AGENDA
PLANNING AND ZONING COMMISSION MEETING
CITY OF CREVE COEUR, MISSOURI
TUESDAY, SEPTEMBER 5, 2017

1. Application #17-031: Minor Site Plan Approval for New Exterior LED Lighting at Congregation Temple Israel, at 10675 Ladue Road

**Subject: #17-024 Mercy Master Sign Plan Amendment To Allow For
A 155 Square Foot “Mercy Kids” Sign**

APPLICATION TO PLANNING AND ZONING COMMISSION
#17-024: AMENDMENT TO THE MASTER SIGN PLAN FOR MERCY
MEDICAL CAMPUS AT 615 S NEW BALLAS ROAD TO ALLOW FOR
A 155 SQUARE FOOT “MERCY KIDS” SIGN

Figure 1: Sign area location and proposed sign area for the Children's Hospital sign authorized with Ordinance 5276

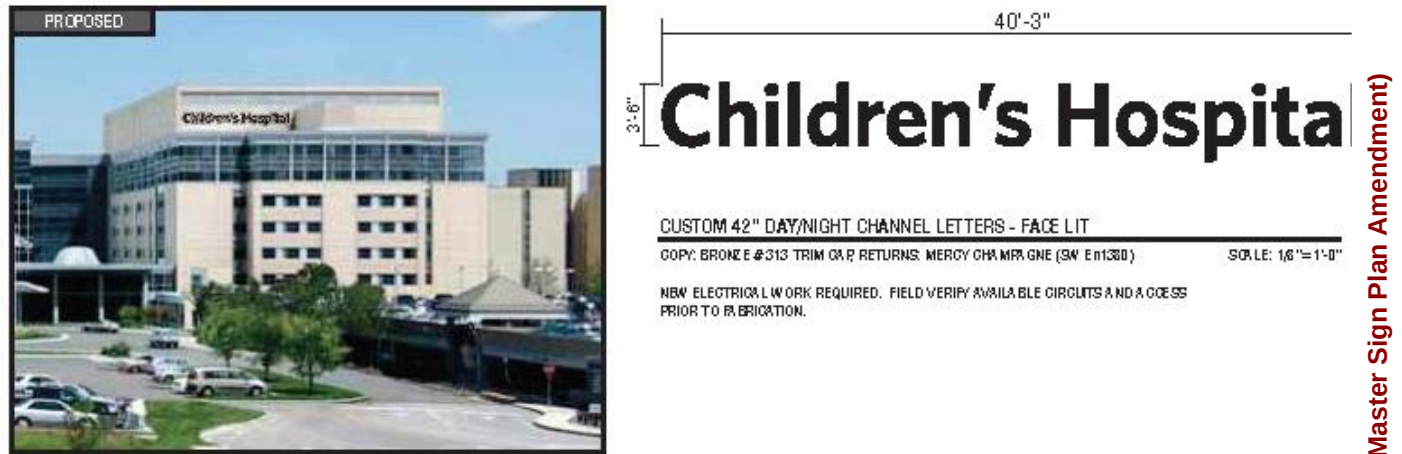
The Mercy Campus received approval for the last Master Sign Plan in 2012. As part of that plan, the Ordinance authorized a sign on the Children's Hospital Building with a sign area of 144 square feet. The proposal is to amend that plan to allow for a second wall sign on the same façade as the existing building with a sign area of 155 square feet to allow for the branded sign of "Mercy Kids". The stated reason for the additional sign is that Mercy Kids is a separate business entity from Mercy and has their own branding as depicted in the proposed logo artwork provided here. The Children's Hospital is considered a hospital within a hospital and the branding should reflect the business operations in that tower.

The previously approved signs reviewed as part of the master sign plan were well-designed in similar style and use of materials and limited to within the campus and away from the residential areas. The existing Children's Hospital sign was coordinated with the adjacent building with similar design and size as the Heart Hospital, and the large Mercy logo sign between the two. The existing Mercy logo sign is 304 square feet of sign area and the Heart Hospital sign was approved at 108 square feet of sign area.

- Ordinance 5276 shall be amended to allow for an additional 155 square foot "Mercy Kid's" wall sign as proposed in the Applicant's Materials submitted June 29, 2017.
- The Applicant shall submit sign permit and/or building permit applications for the proposed sign.
- The Applicant shall follow the Master Signage Plan received August 10, 2012 and as amended, for all new or altered signage on the campus, as approved by the City of Creve Coeur. The location, size, shape, color, type, and design of each sign shall not substantively depart from the Master Sign Plan, unless approved by the City of Creve Coeur.
